My comments are related to the applicant's responses to written representations at Deadline 1 addressing HYD-003 for Lavendon. My submission contests both the applicant's response and provides additional supporting evidence that the applicant has not, in my opinion, adequately taken into consideration statutory and engineering assessment in sufficient detail to draw their conclusions made for flood risk assessment for Site G

RESPONSE TO APPLICANT'S RESPONSES TO WRITTEN REPRESENTATIONS AT DEADLINE 1 : HYD-003 – LAVENDON

Figure 4-5: Lavendon - Recorded Rainfall Radar Depth Plot

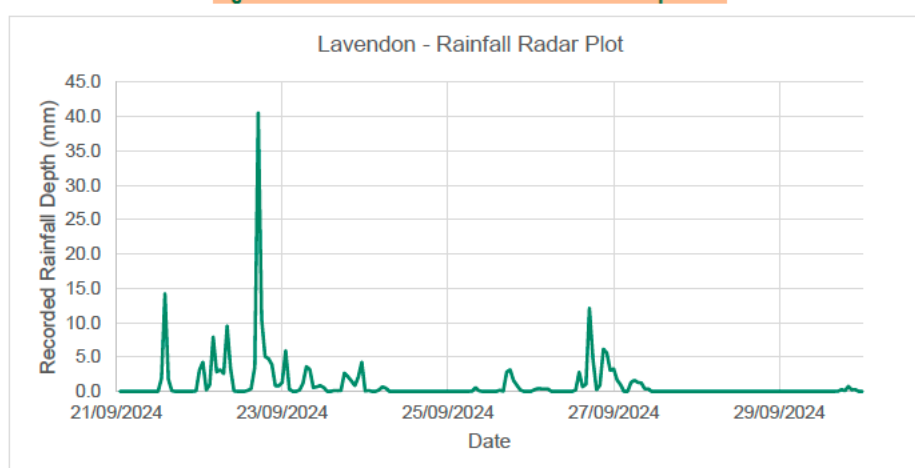
Table 4-2 shows the largest observed 144-hour (6-day) total (cumulative 60 min rainfall data) was 222 mm and was recorded in Lavendon. Maximum rainfall depths were high across all hotspots, most notably in Lavendon, Bradwell and Bletchley.

The developer is requested to explain the different conclusions drawn between the Section 19 Report referenced above and their own investigations, where apparently the same source data was used.

CDC2: Lavendon

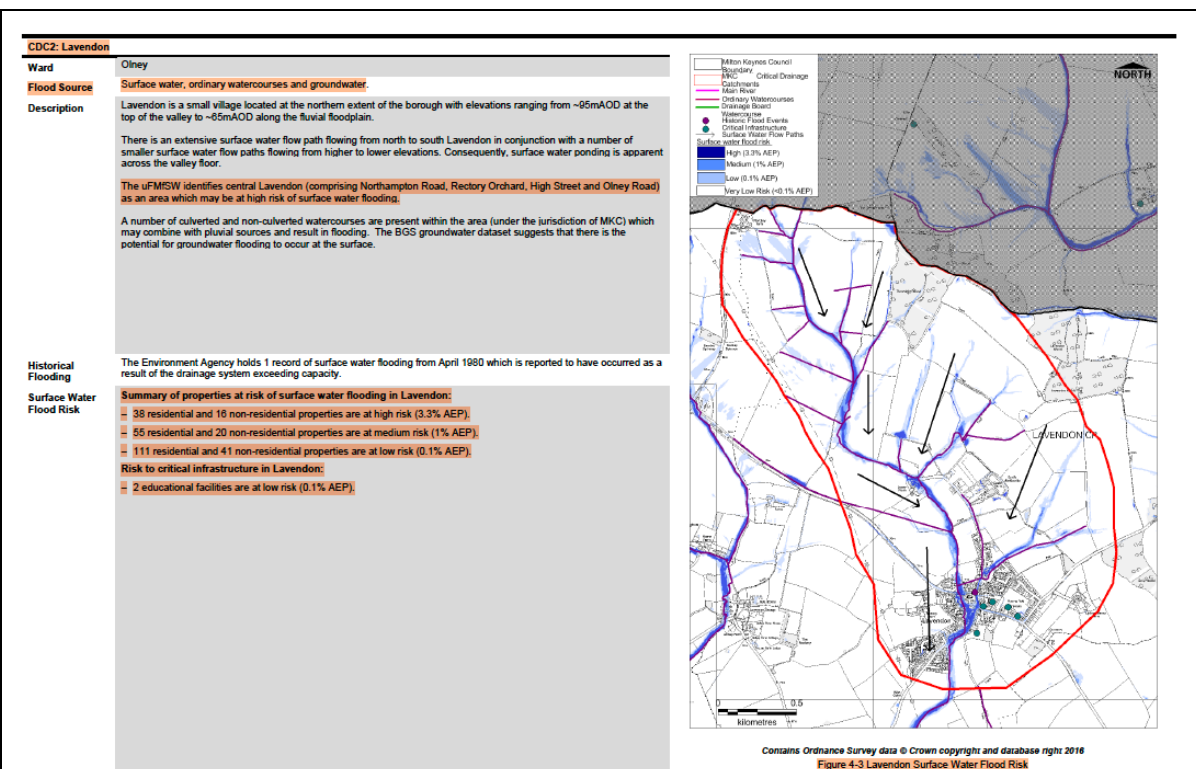
The developer's attention is drawn to the Surface Water Flood Risk comments as well as the surface water flow paths. **Three of the surface water flow paths run through sites G-9 and G-13.**

7. The developer appears to have omitted key information from the Milton Keynes Surface Water Management Plan (Final Report April 2016). This plan contains the surface water flow paths in Lavendon - three of the surface water flow paths run through sites G-9 and G-13.

Location F

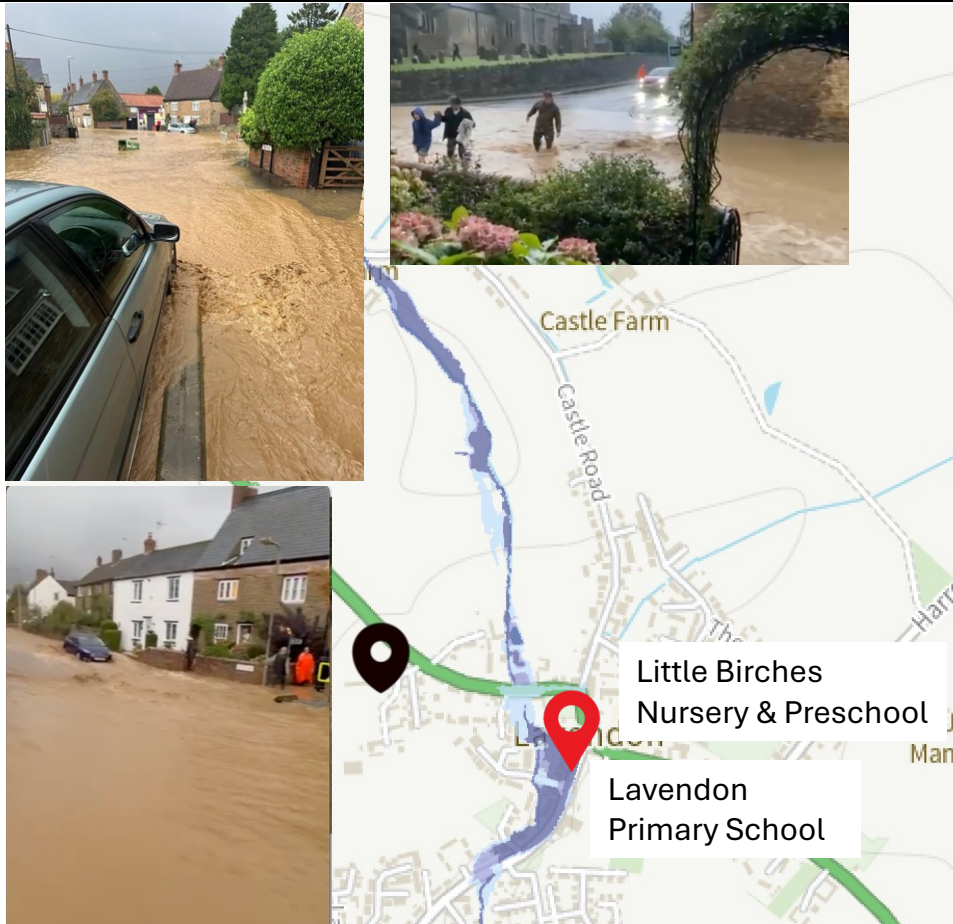
High water
mark from
Sep '24
flood

The developer, in accordance the documents referenced as part of their own design and FRA, should read the notes from the Environment Agency (EA) and Lead Local Flood Authorities (LLFAs) and Flood Estimation Handbook (FEH) and include these as Historic Flood Events to recalibrate their hydraulic models.

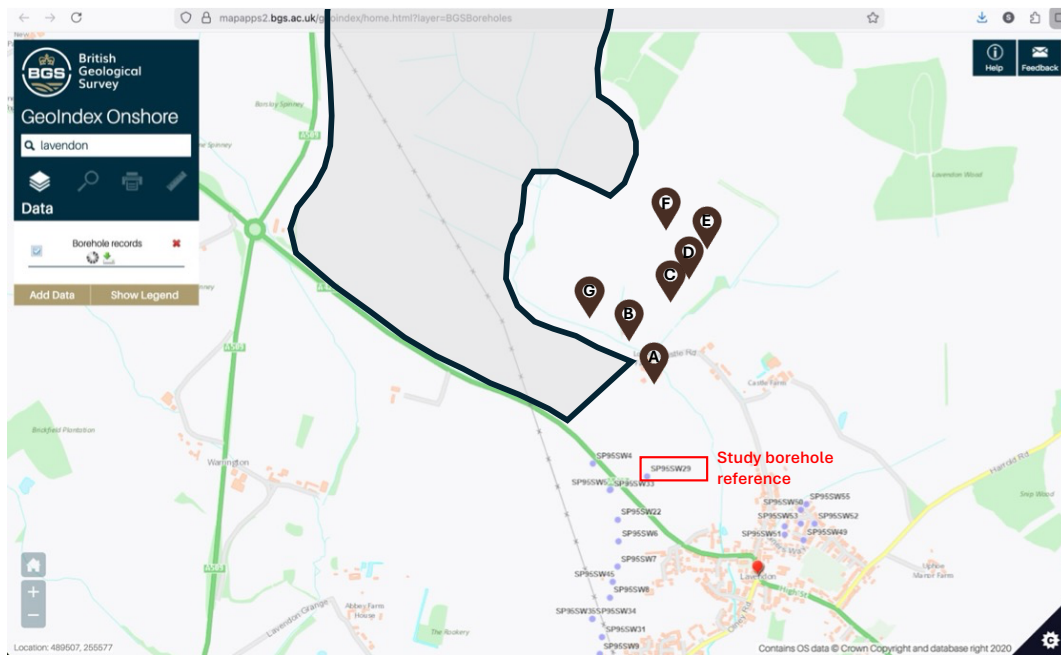
In Clause 1.6.2 it is stated that the geological mapping is available at a scale of 1:50,000 and as such may not be accurate on a Site-specific basis.

The respondents took the time to physically visit the site and dig coordinated trial holes at more relevant points to the development. Trial holes were excavated until hard limestone was found. The plan/location of these trial holes compared to the quoted borehole reference is:
